CROWN STREET WOLLONGONG

RTS DESIGN RESPONSE
WOLLONGONG DEVELOPMENTS NO.8 PTY LTD

RtS DESIGN RESPONSE PURPOSE

Ground Level plan
RtS Amendment

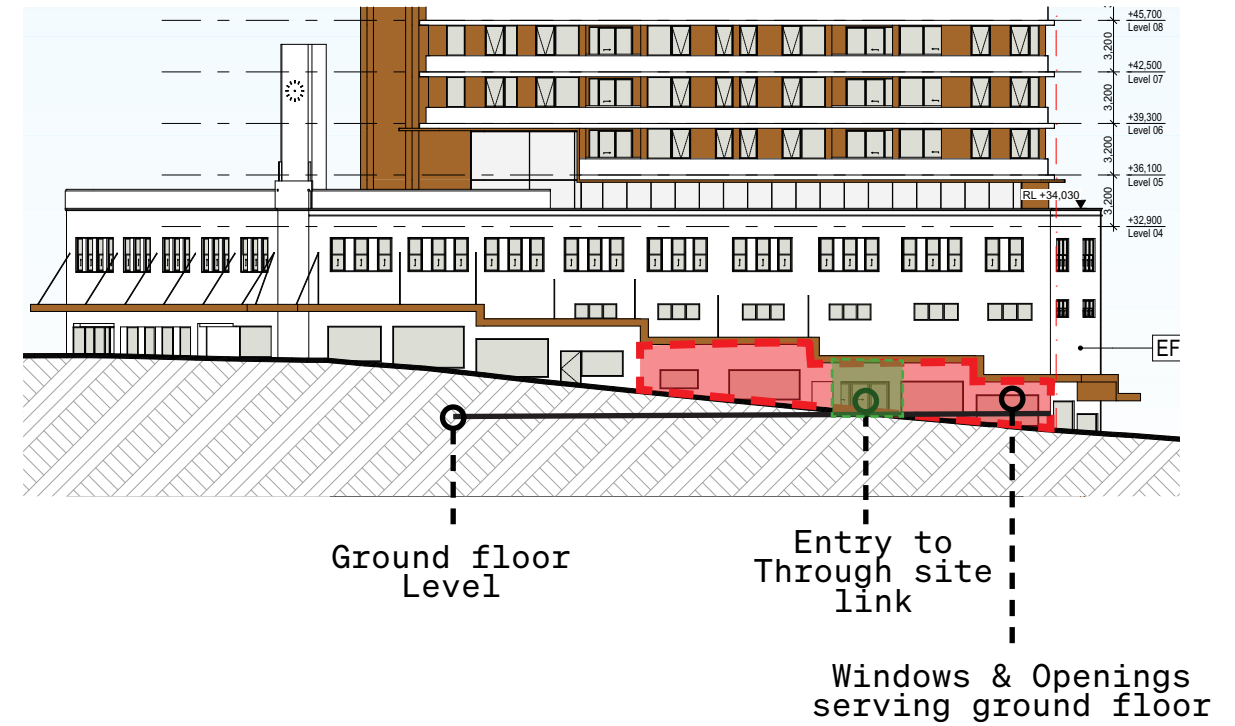
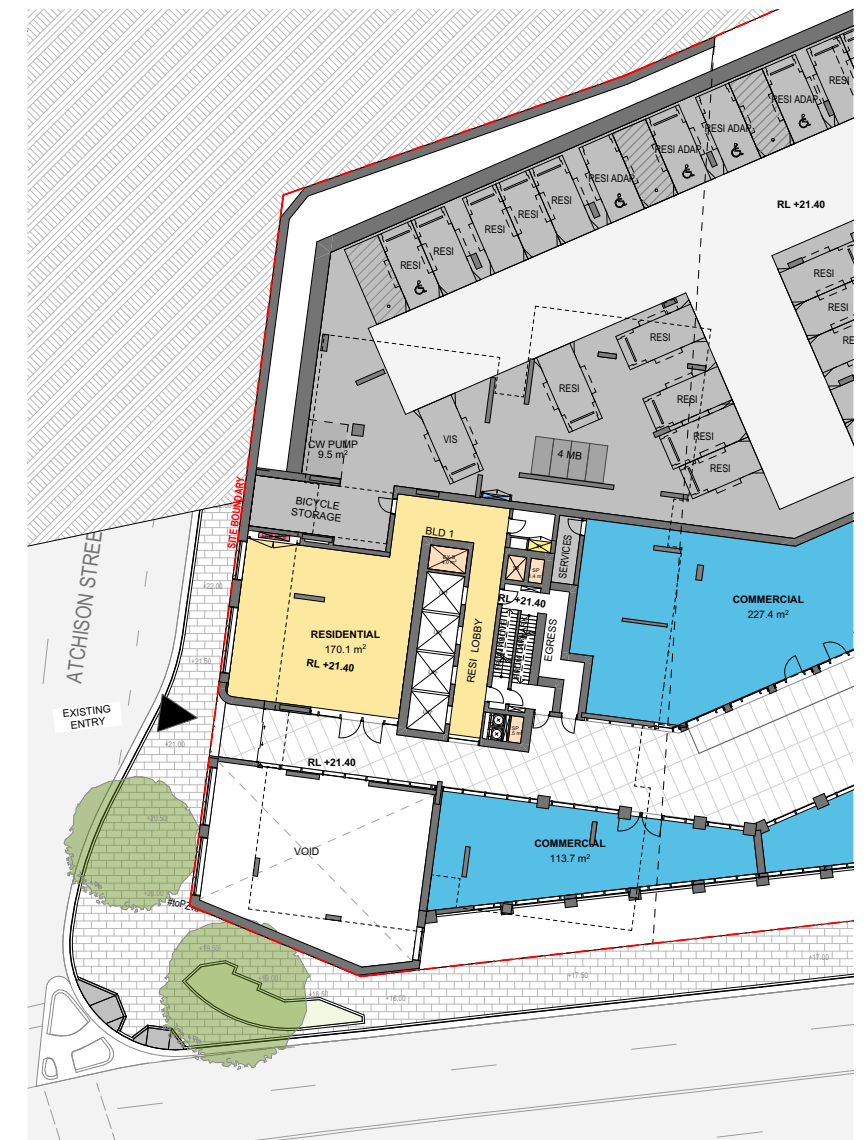
Provide active uses along the ground level of the Marcus Clarke Building, to support its adaptive reuse and contribute positively to the Crown Street CBD street scape.

The interface of the Marcus Clark Building has been refined to enhance its presentation and relationship with the public domain. Along Crown Street, the upper-level access stair has been recessed to improve the building frontage. Existing windows along Atchison Street that were previously obscured have been reopened to reinstate the building's historic façade rhythm and provide increased passive surveillance. The Building 1 fire stair egress has been relocated to minimise its impact on Atchison Street, while the adjacent retail tenancy has been reconfigured to provide direct street access at the corner of Atchison and Burelli Streets, creating a more active and engaging street interface.

Lower Ground plan
RtS Amendment

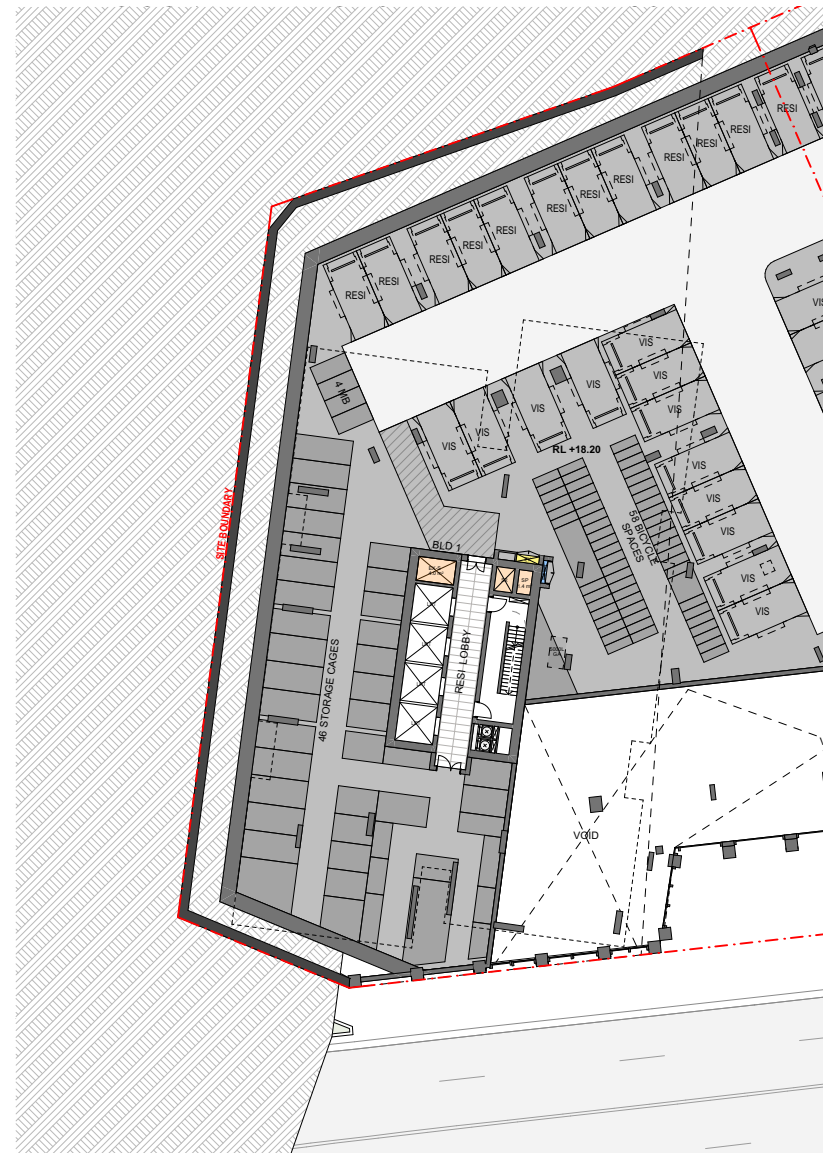
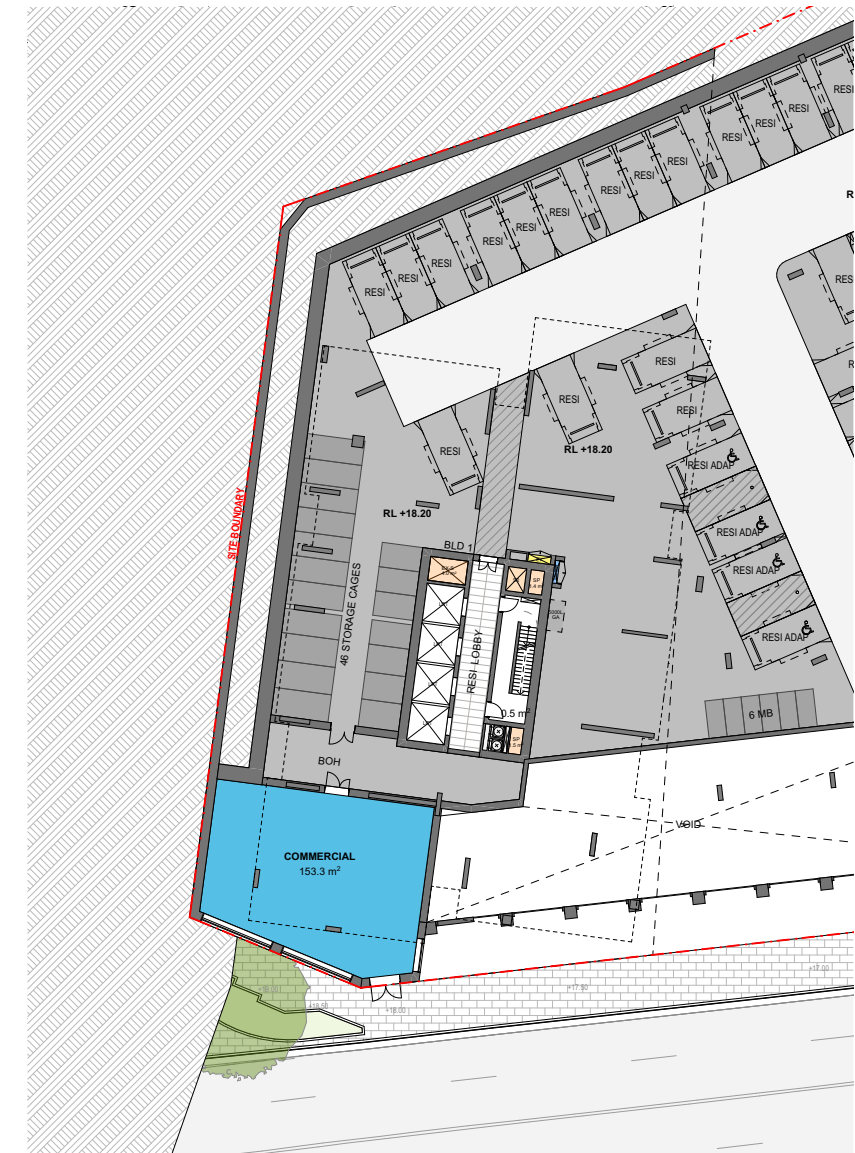
Provide active uses along the ground level of the Marcus Clarke Building, to support its adaptive reuse and contribute positively to the Crown Street CBD street scape.

The interface of the Marcus Clark Building has been refined to enhance its presentation and relationship with the public domain. Along Crown Street, the upper-level access stair has been recessed to improve the building frontage. Existing windows along Atchison Street that were previously obscured have been reopened to reinstate the building's historic façade rhythm and provide increased passive surveillance. The Building 1 fire stair egress has been relocated to minimise its impact on Atchison Street, while the adjacent retail tenancy has been reconfigured to provide direct street access at the corner of Atchison and Burelli Streets, creating a more active and engaging street interface.

Tenancy adjusted to have straight access from Burelli Street

AMENDED MEZZANINE LEVEL

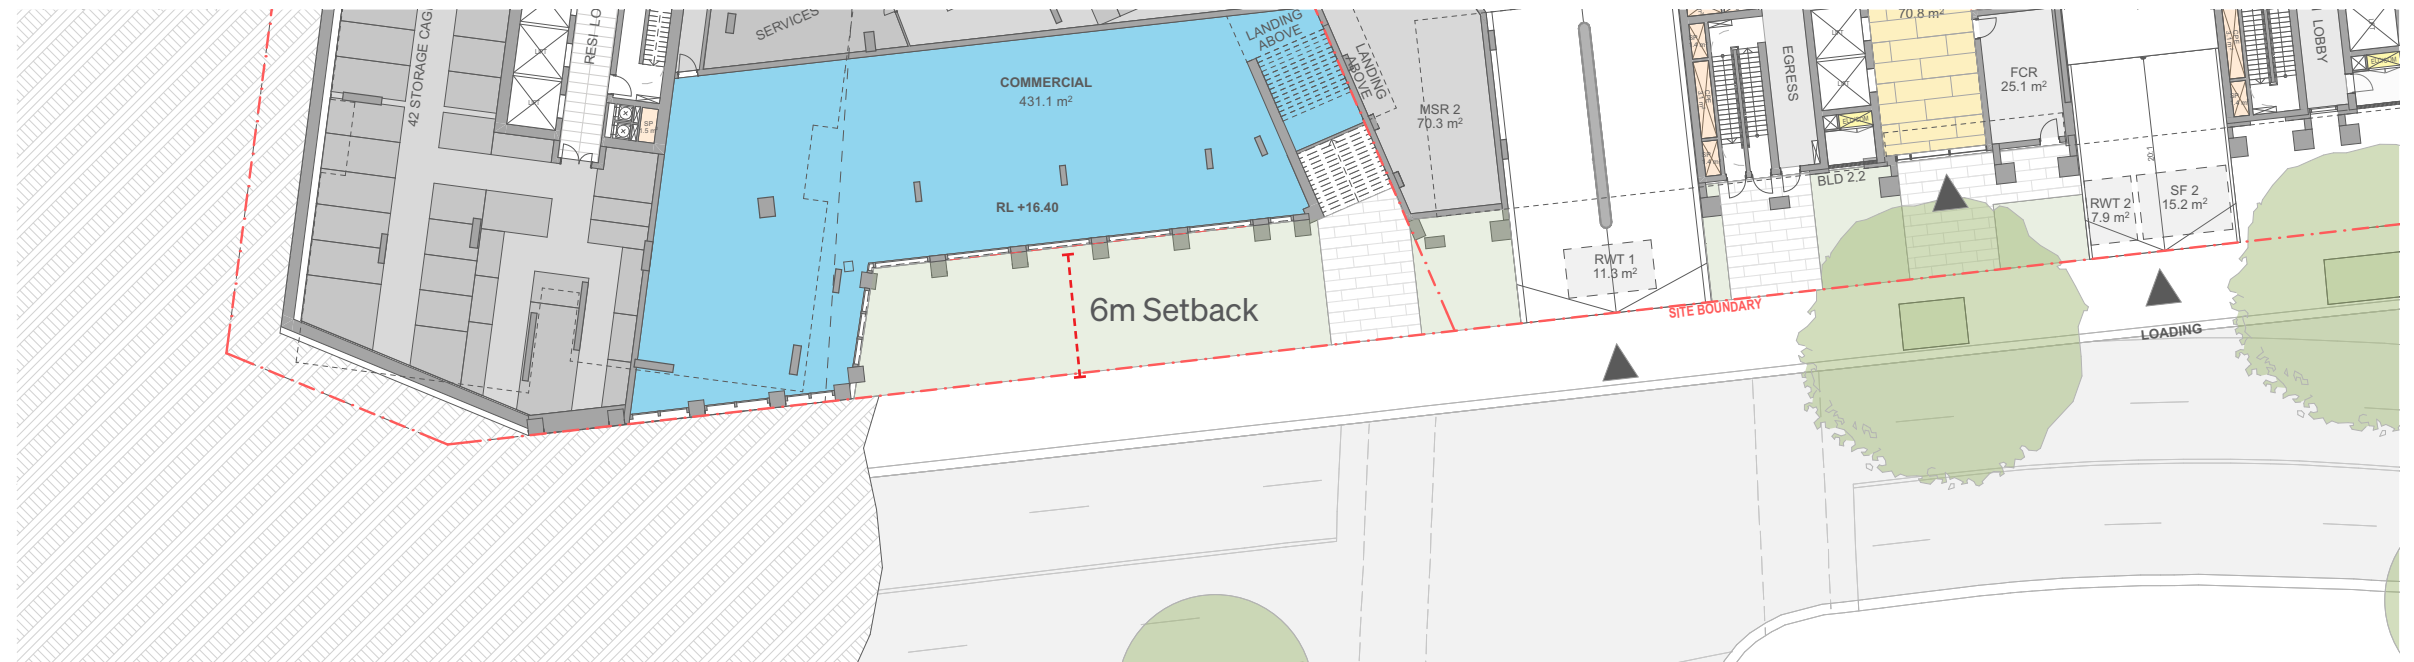
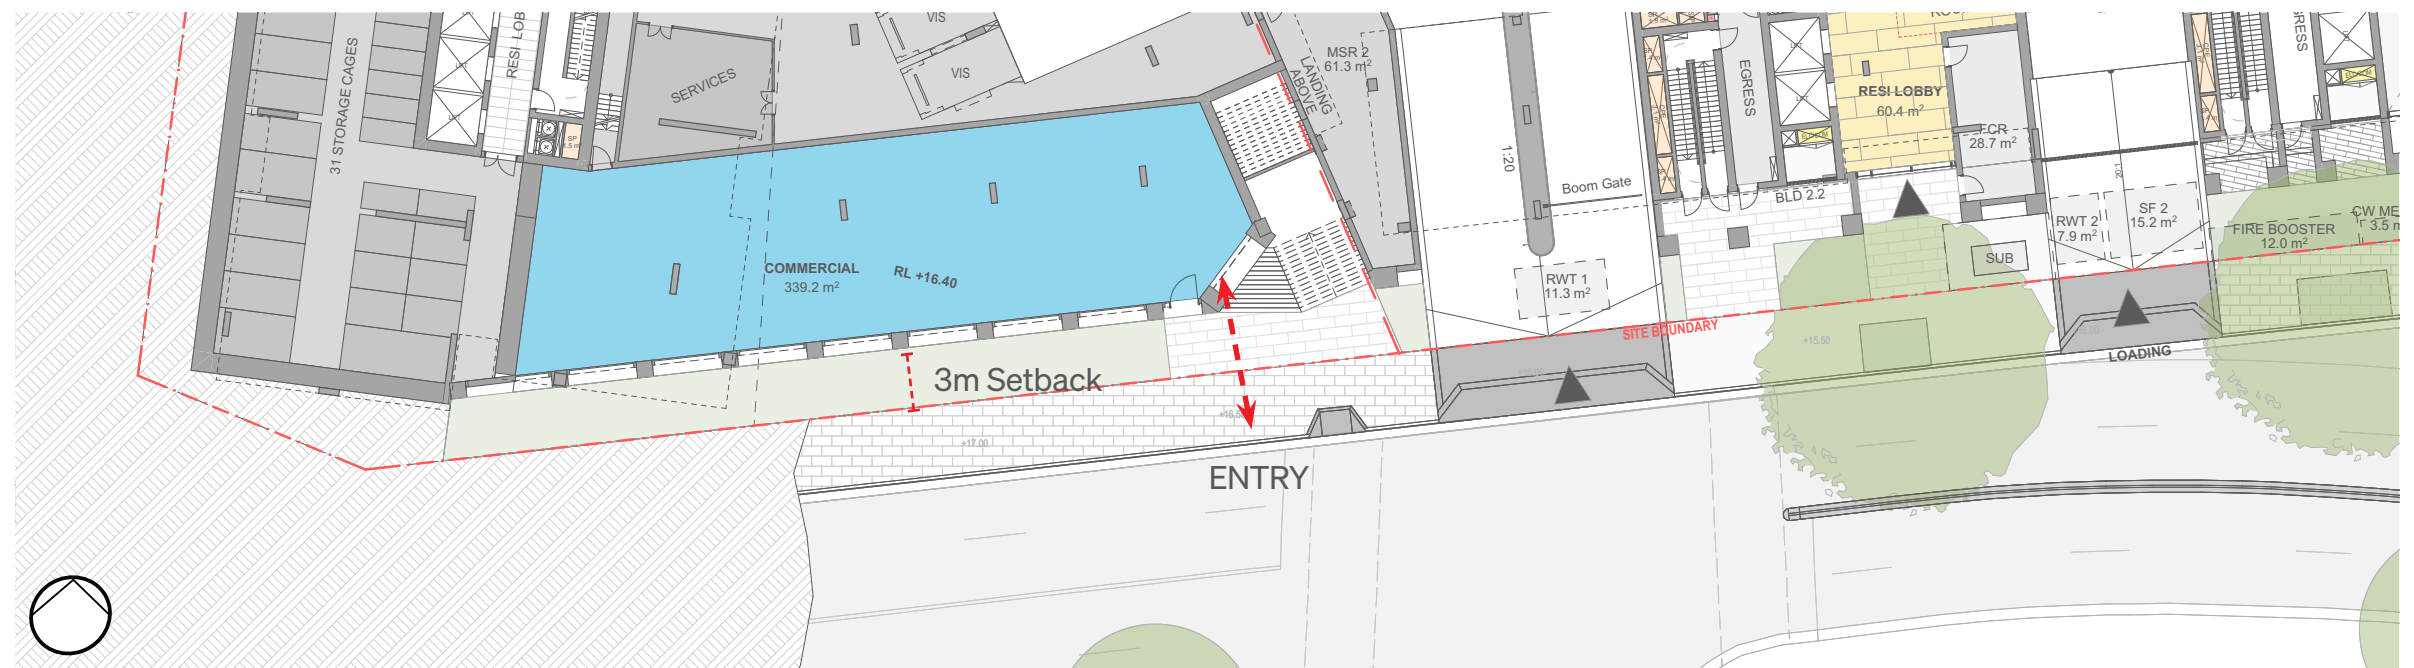
Improve the interface of the commercial tenancy with the street at the south-west corner of the building by improving its alignment to the street and providing an accessible, street-level entry. Ensure any landscaping in front of the tenancy maintains clear sightlines to the street.

The commercial tenancy line at the south-west corner of the building has been reduced to 3 metres. In addition, the landscaping in front of the commercial tenancy has been redesigned as a more civic-style landscape treatment to improve clear sightlines and provide level, accessible entry to the tenancy.

AWNING PLAN

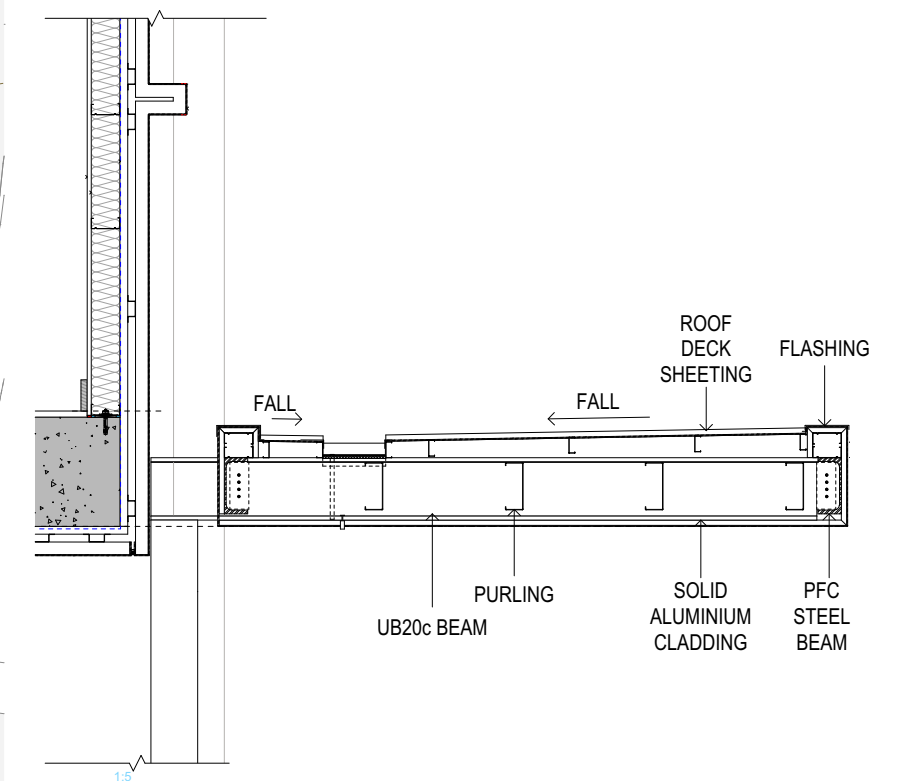
Provide an awning strategy for the development, detailing awnings along all street frontages, including the burrelli and Kiera Street frontages

Response
Awning Strategy plan included.
Refer to drawing DA3026.
